BWROG HUMAN FACTORS ENGINEERING - CONTROL ROOM SURVEY SUPPLEMENT

In response to recently formulated regulatory requirements for design reviews of nuclear power plant control rooms (NUREG-0660, NUREG-0700), Cleveland Electric Illuminating Company has undertaken a preliminary human factors evaluation of the Perry control panels. This one week review was performed by operations and engineering personnel from three utilities, two human factors consultants, and a representative from General Electric Company. General conclusions of the survey team are as follows:

PHOTO #22

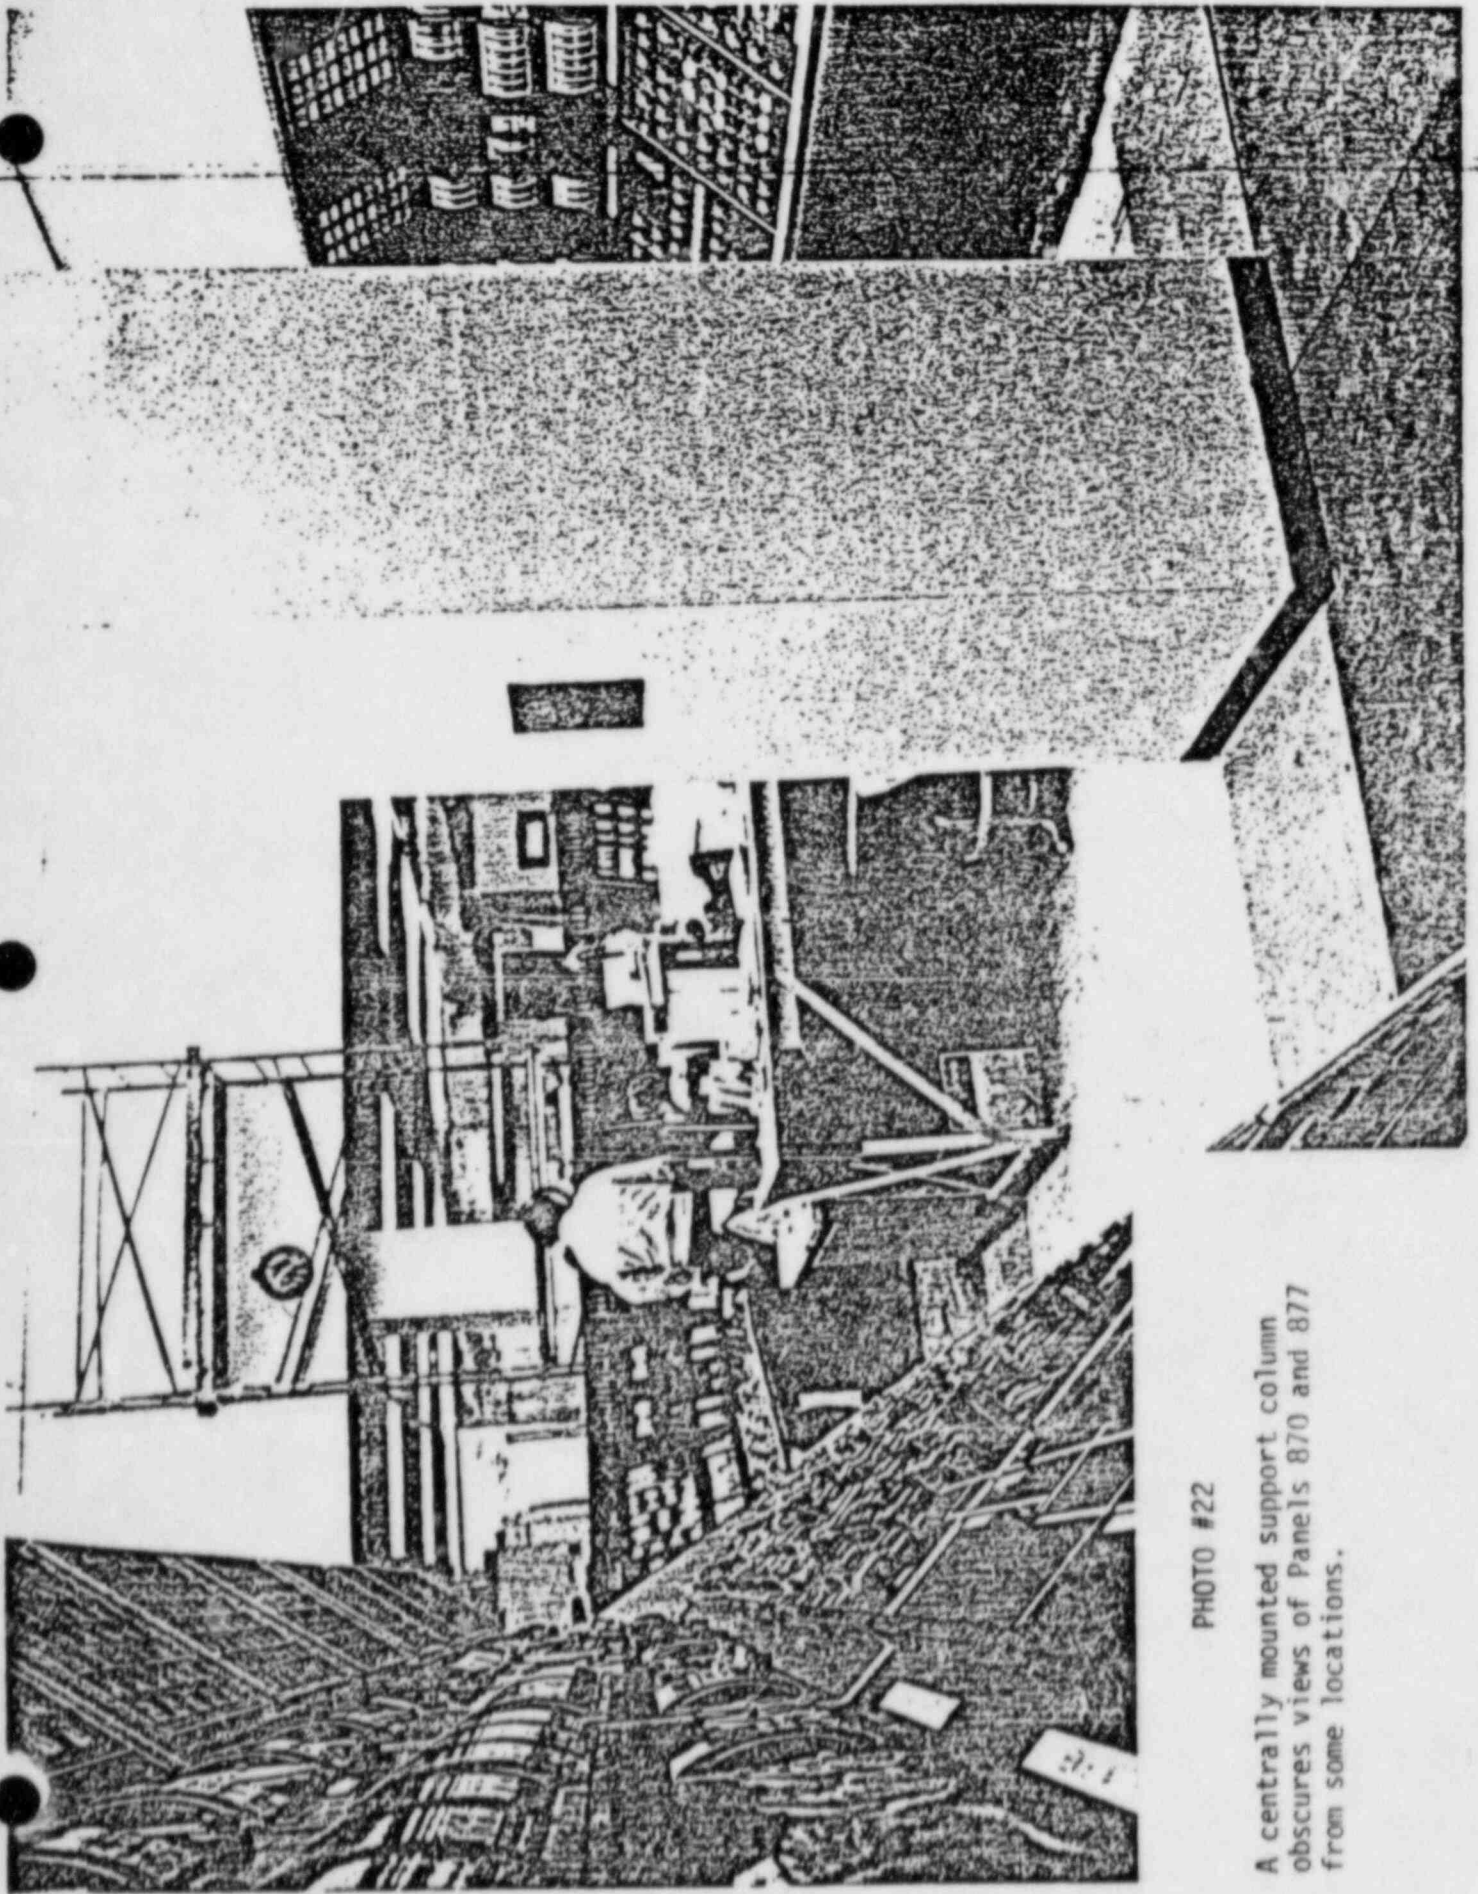
A centrally mounted support column obscures views of Panels 870 and 877 from some locations.

PHOTO #23

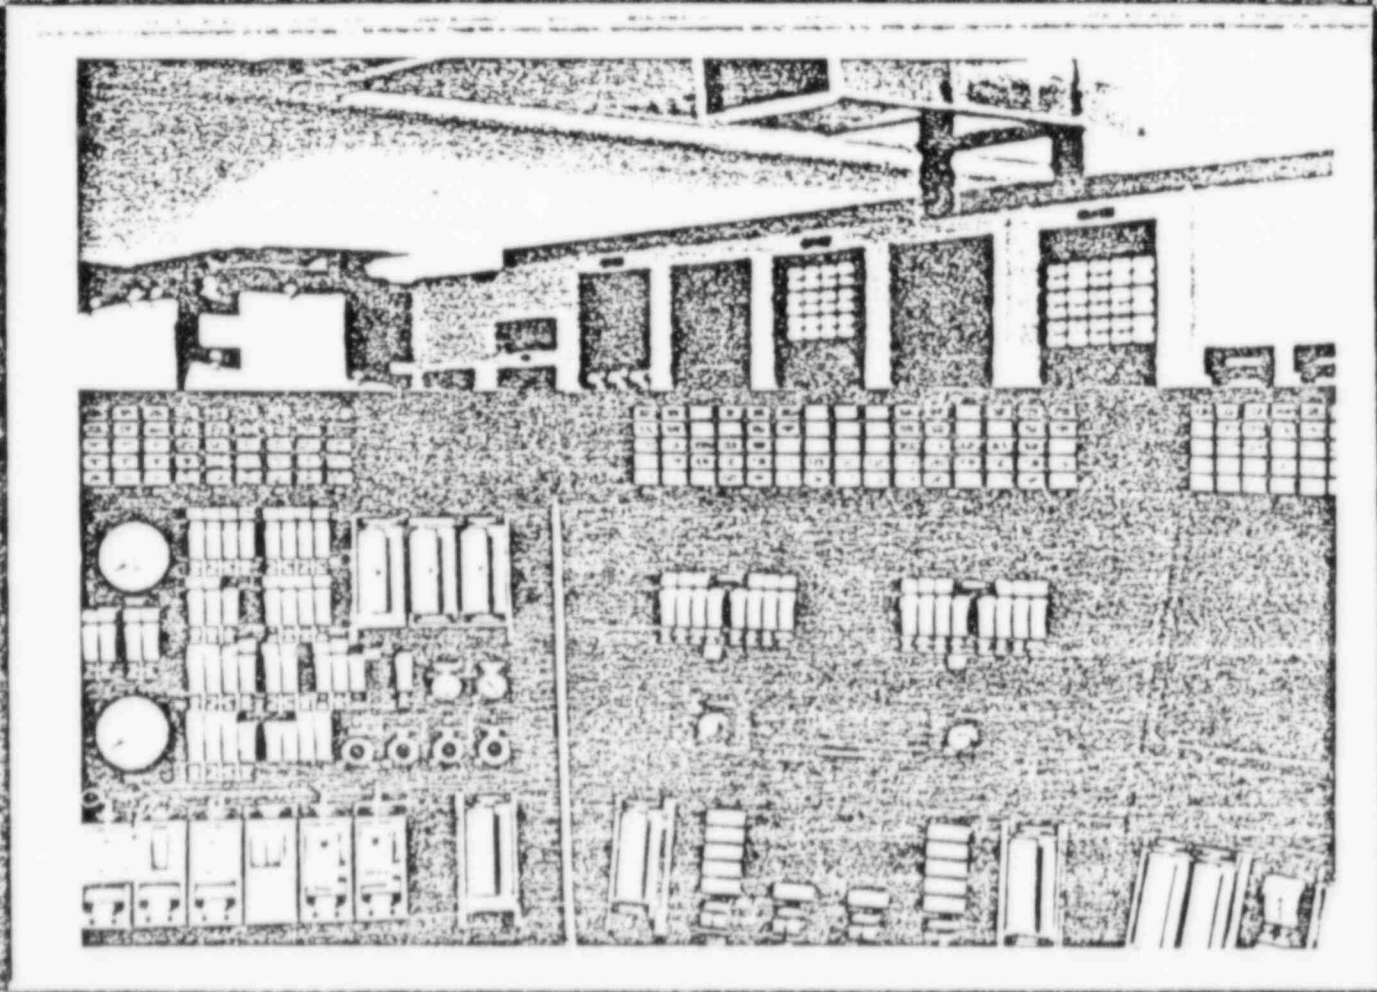
Panel 680 blocks views of the radiation monitoring panel (photo taken from a standing position).

PHOTO #24

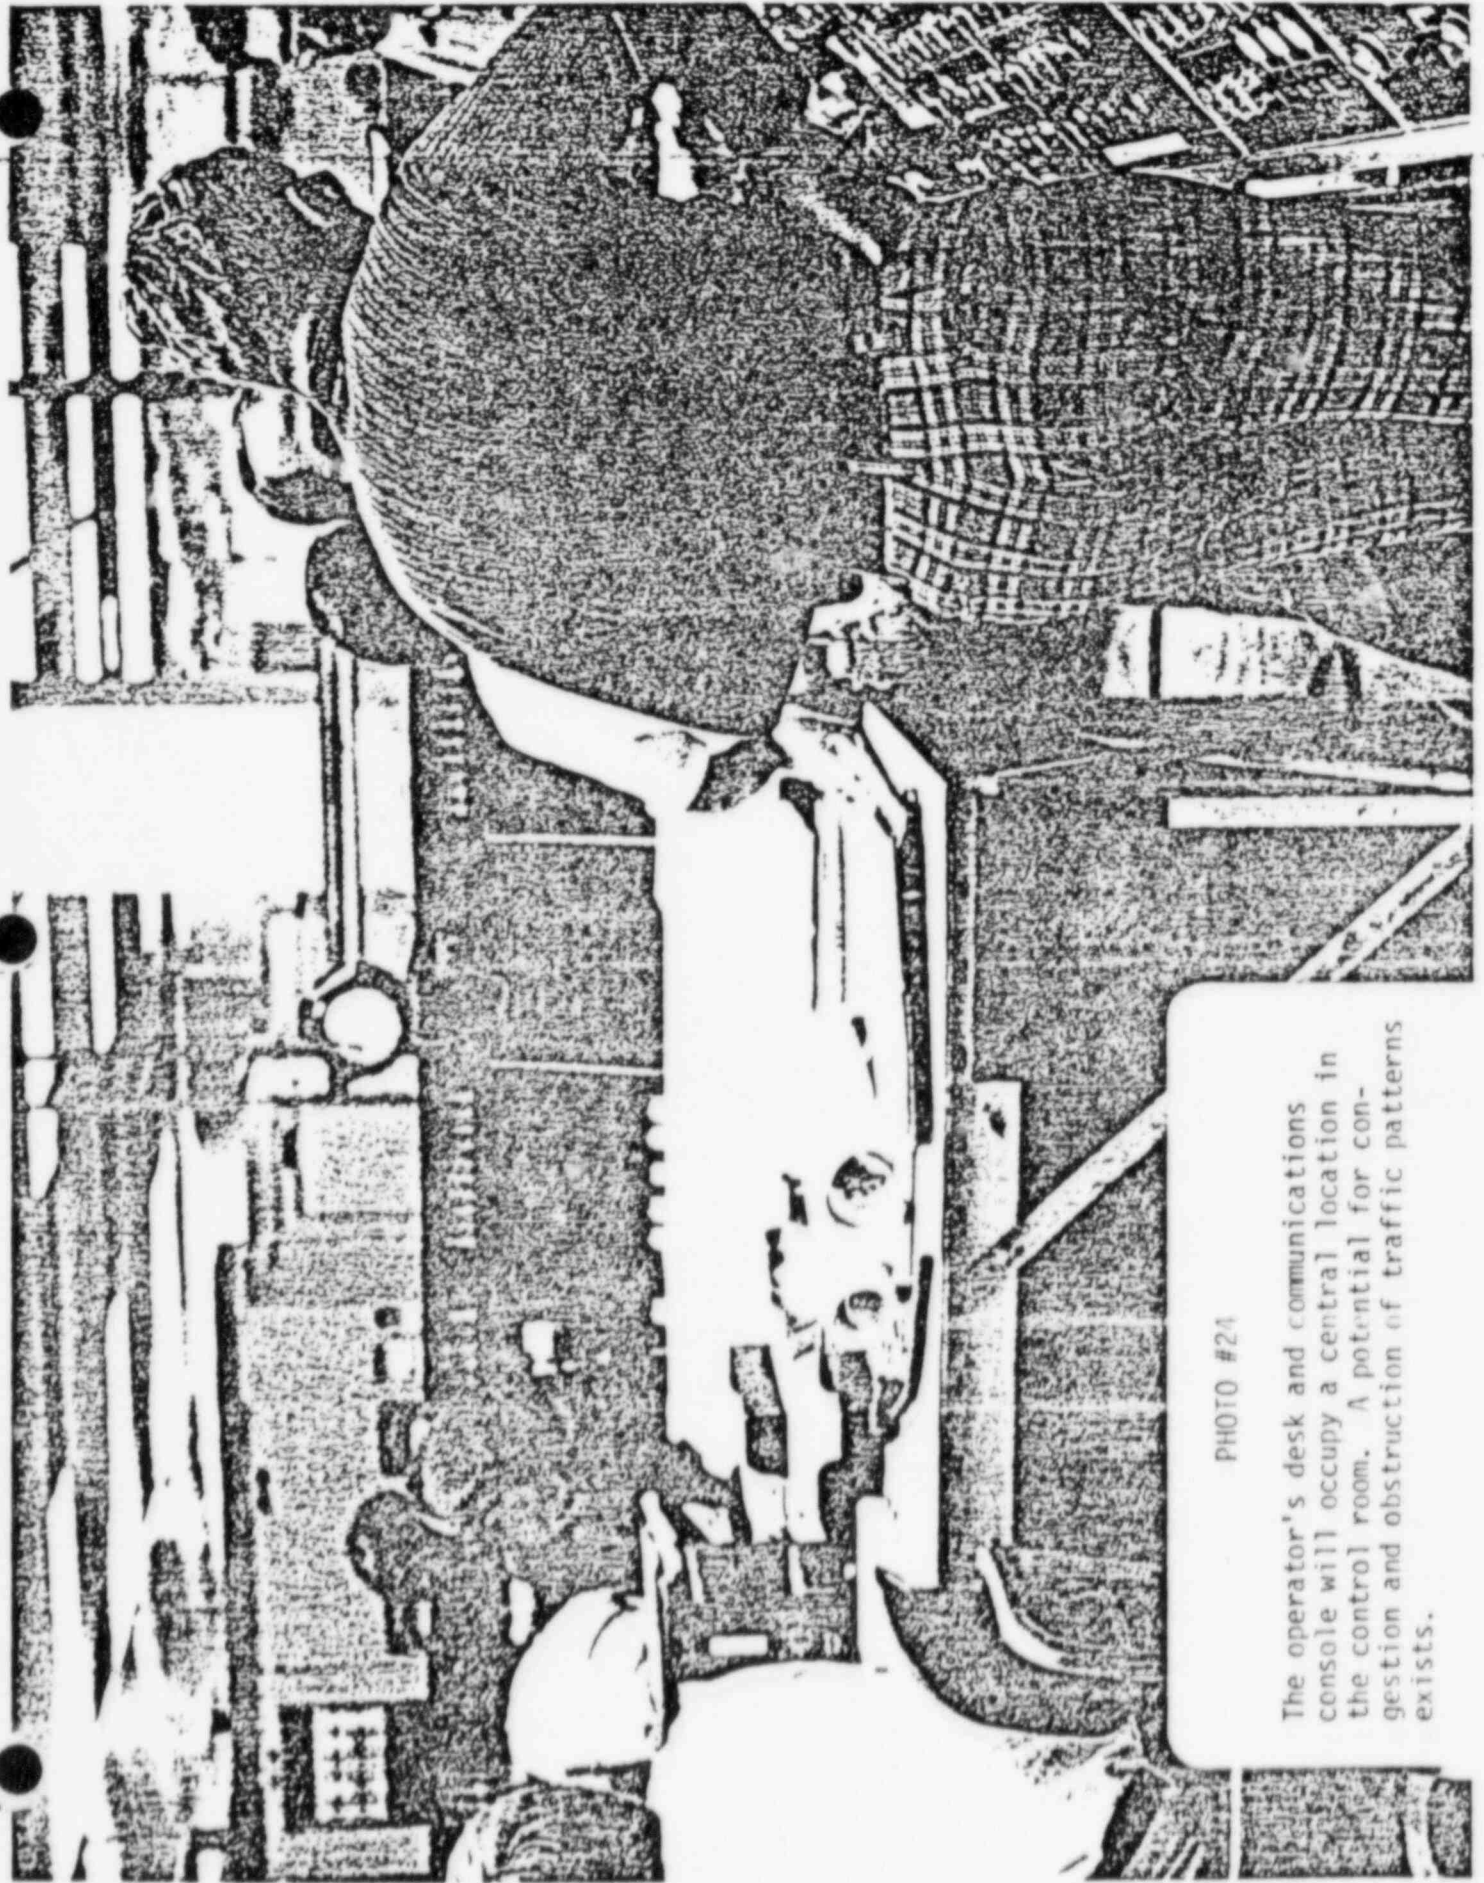
The operator's desk and communications console will occupy a central location in the control room. A potential for congestion and obstruction of traffic patterns exists.

PHOTO #25

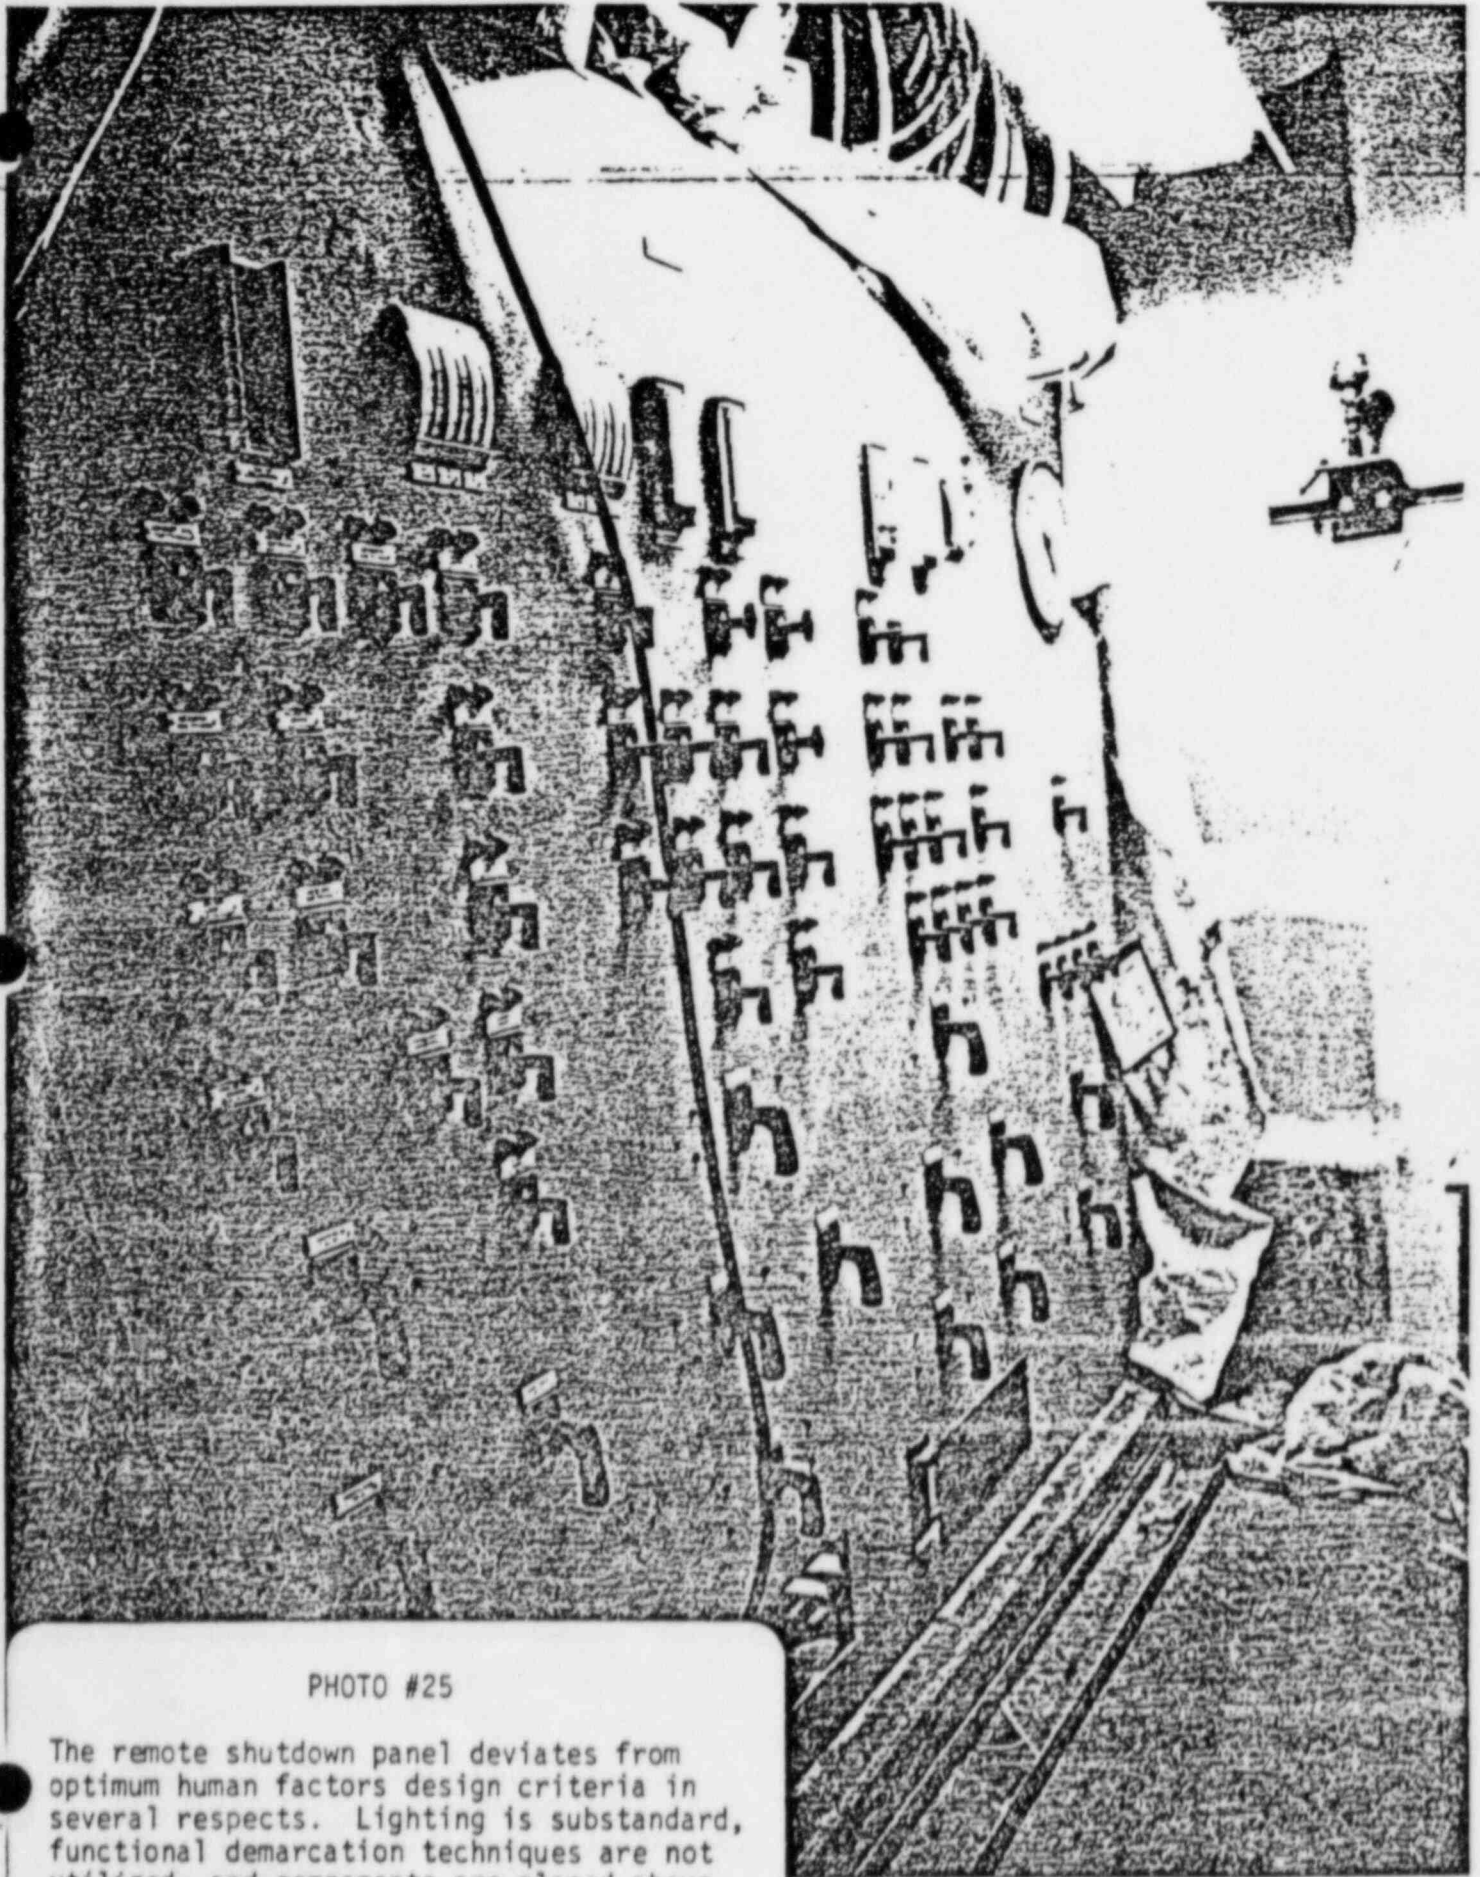
The remote shutdown panel deviates from optimum human factors design criteria in several respects. Lighting is substandard, functional demarcation techniques are not utilized, and components are placed above and below recommended heights.

PHOTO #29

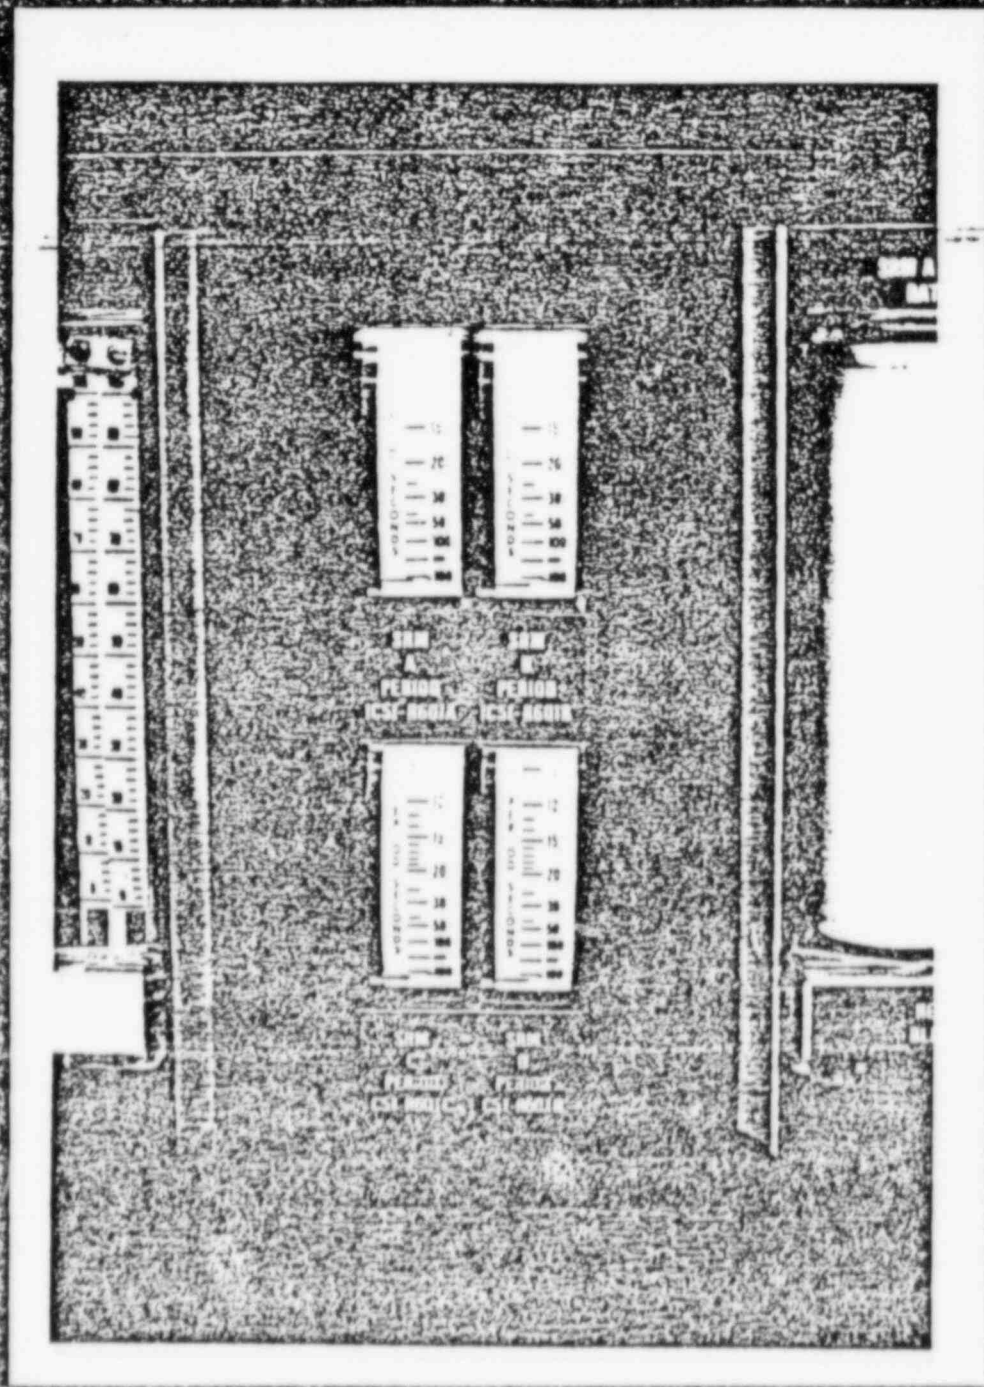
The normal control band on the SRM period indicators subtends a very small visual arc when viewed from a normal operating position.
